Project	IEEE 802.16 Broadband Wireless Access Working Group < http://ieee802.org/16 >	
Title	Signaling Acknowledgment Mechanism in MR Network	
Date Submitted	2007-03-28	
Source(s)	Qu Hongyun, Mary Chion, Cancan Huang, Sean Cai Liu Yang, Chen Yuqin ZTE Corporation 712/2, Liantang Pengji Industrial Park, Luohu District, Shenzhen, P.R.China 518004 Mo-Han Fong Nortel 3500 Carling Avenue Ottawa, Ontario K2H 8E9	Voice:+86-755-26773000 exd. 6614 Fax:+86-755-26773000 exd. E-mail: mchion@zteusa.com
Re:	IEEE 802.16j-07/007r2:“Call for Technical comments and contributions regarding IEEE Project P802.16j”	
Abstract	This document presents sleep mode operations for IEEE 802.16j. The existing IEEE 802.16e messages are reused and new parameters are introduced in order to facilitate the sleep mode management in IEEE 802.16j.	
Purpose	Propose an efficient signaling acknowledgment operations for IEEE 802.16j	
Notice	This document has been prepared to assist IEEE 802.16. It is offered as a basis for discussion and is not binding on the contributing individual(s) or organization(s). The material in this document is subject to change in form and content after further study. The contributor(s) reserve(s)

Figure 201 - Acknowledgement Header

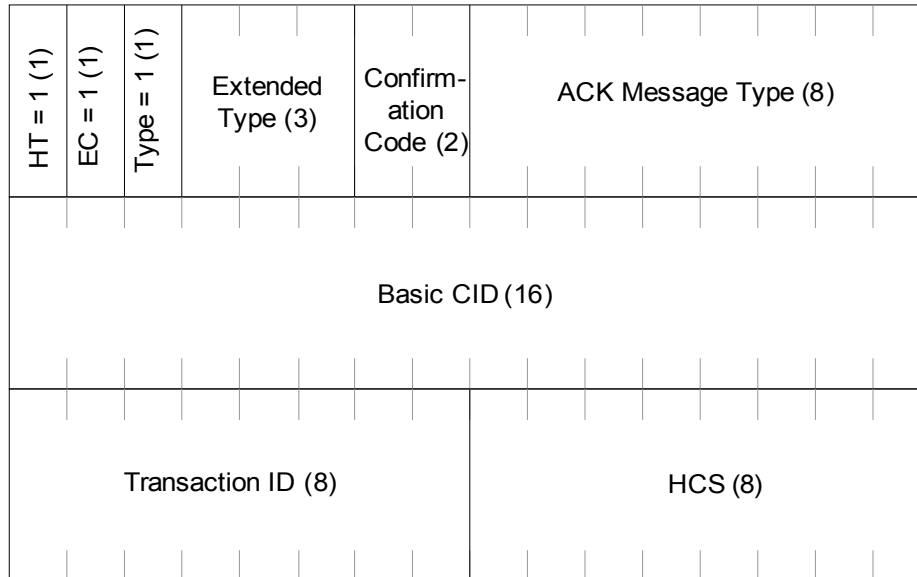
6.3.2.1.2.2.3 Acknowledgment Header

An Acknowledgment Header is sent by an RS as a response to a MAC management messages received from the MR-BS or its superordinate RS that requires acknowledgment. The RS sends this header to the MR-BS or its superordinate RS as an indication of the message reception. The Acknowledgment Header shall be sent on RS's basic CID. The Acknowledgment Header is illustrated in Figure 201.

The Acknowledgment header shall have the following properties:

- a. This is a MAC signaling header type II. The length of the header shall always be 6 bytes.
- b. The Type field of this header shall be set to 1.
- c. The Extended Type field of this header shall be set to 0b010
- d. The content of the header is listed in table 7k.
